**CITY OF RAMSEY LAND USE APPLICATION
TECHNICAL REVIEW FILE**

DATE	11/26/2014	PROJECT ADDRESS	5650 ALPINE DR NW
PROJECT TITLE	FIRE STATION NO. 2: ALPINE DRIVE		
ESCROW #	N/A		
DEPARTMENT:	Community Development: Planning Division (Comprehensive Plan and Zoning Code)		
TECHNICAL REVIEWER:	Name: Tim Gladhill, Community Development Director Phone: 763-433-9826 Email: tgladhill@cityoframsey.com

DATE	NOVEMBER 24, 2014	PROJECT ADDRESS	ALPINE DRIVE AND HELIUM STREET
PROJECT. TITLE	FIRE STATION NO. 2 PRELIMINARY PLAN REVIEW		
ESCROW #			
DEPARTMENT:	Engineering		
TECHNICAL REVIEWER:	Name: Leonard Linton Phone: 763 433-9834 Email: llinton@ci.ramsey.mn.us

We offer the following comments regarding updated plans dated November 17, 2014 prepared by Wenck in association with BKV Group.

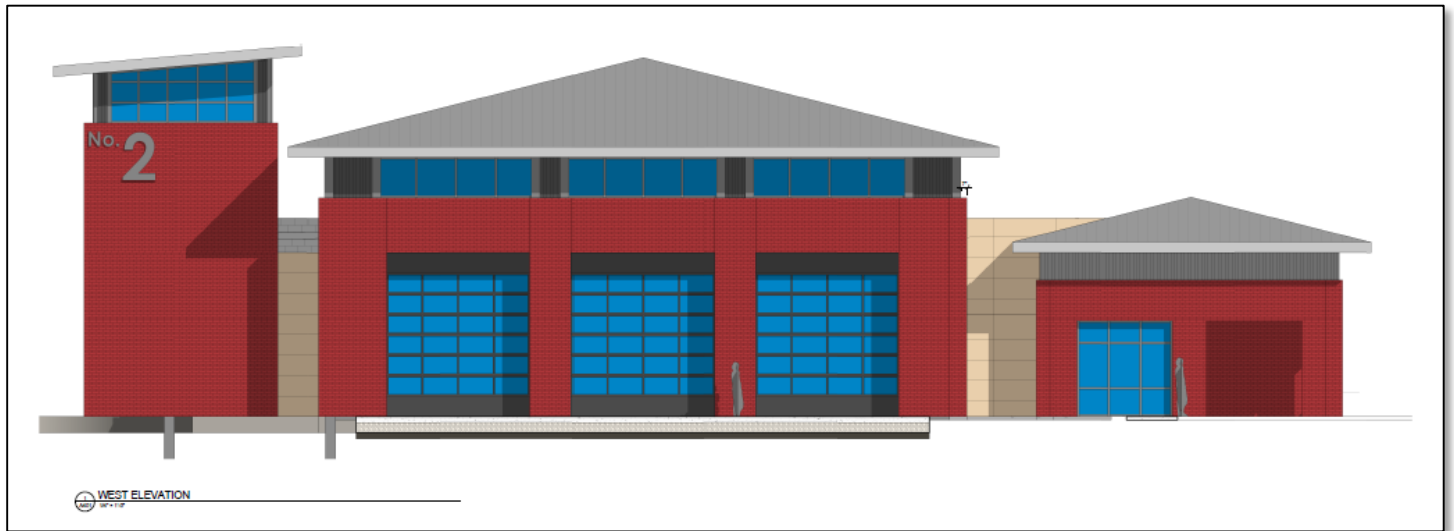
¹ The hose tower measures approximately thirty-seven (37) feet. City Code [Section 117-358](#) (Permitted encroachments) exempts fire and hose towers from height limitations.

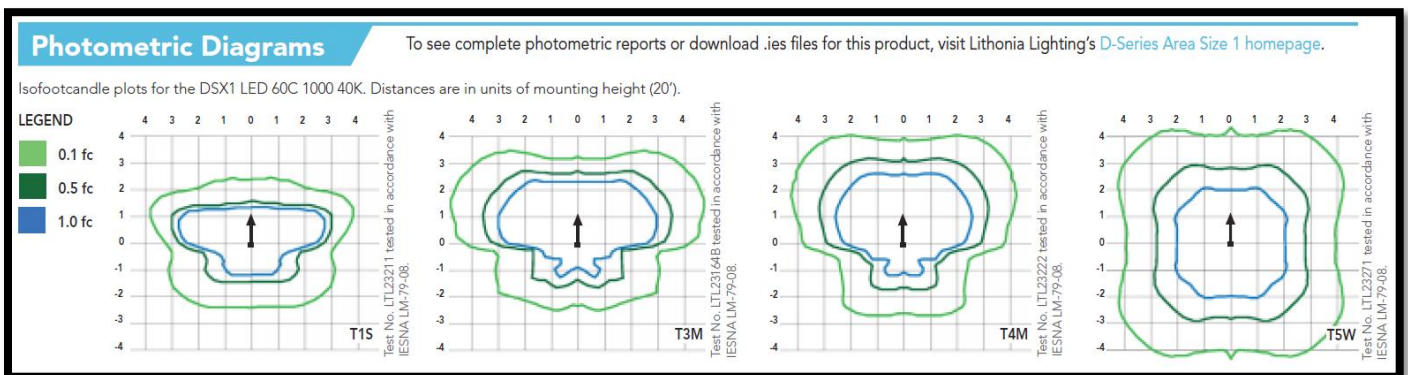
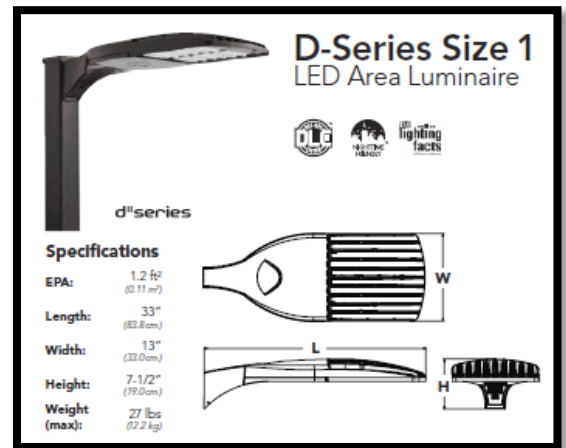
The Trash Enclosure is planned to be located on the exterior building on the east-facing façade. This trash enclosure will consist of materials to match the building on two (2) sides, with an opaque gate on the north facing side. A chain link fence that will pre-exist to secure the existing radio tower on the site will serve as the fourth wall. Staff finds this acceptable, as the existing radio tower and adjacent Connexus sub-station will provide more than adequate screening to any adjacent or otherwise visible areas.

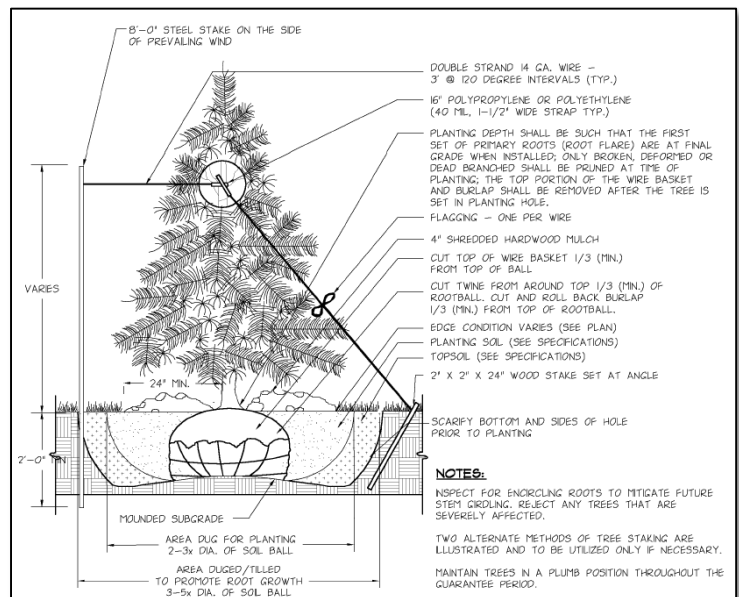
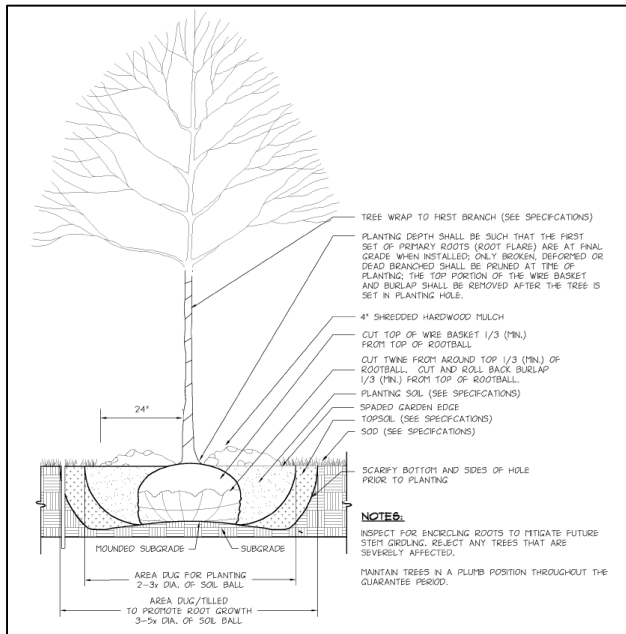
- A planting detail must be included. It shall either incorporate the City's tree planting detail or, at a minimum, include the following:
 - Planting depth shall be such that the 1st set of primary roots is at finished grade
 - Only prune out dead/broken/deformed branches at time of installation
 - Removal of upper portion of wire basket and burlap after being placed in planting hole if using B & B stock.
 - 2-4 inches of wood chip mulch shall be included around all trees. Mulch shall not be piled against the trunk of trees.

- Add a note to the Landscape Plan stating that all disturbed areas not otherwise improved with impervious surfacing shall be covered with four (4) inches of topsoil meeting MnDOT's specification for Premium Topsoil Borrow (3877.3).

- Shrub size at time of installation shall be at least twenty-four (24) inches.
- The four (4) Fall Fiesta Sugar Maples should be replaced with an alternative species, as they don't tolerate urban conditions well (heat, compacted soils, deicing salts, etc.).

- Three (3) Imperial Honeylocusts and four (4) Thornless Hawthorns along the reconstructed trail are shown within a transmission line easement. Written acknowledgement/acceptance of the proposed plantings from the easement holder should be obtained prior to installation of the trees. As an alternative, plantings should be relocated outside this easement to avoid conflict (future removal) with the purpose of the easement.

- Planting plan and schedule conflict regarding the prairie dropseed and little bluestem numbers. This should be reconciled.
- Trees/shrubs shall be warranted for a minimum of two (2) years.

- Boulevard area along Helium Street shall be finished with topsoil and sod (if it is not already). This note should be added to sheet L100.
- The two (2) Princeton Elms south of the trail should be shifted to the east to ensure a clear site line for both pedestrians and motorist at the trail crossing.
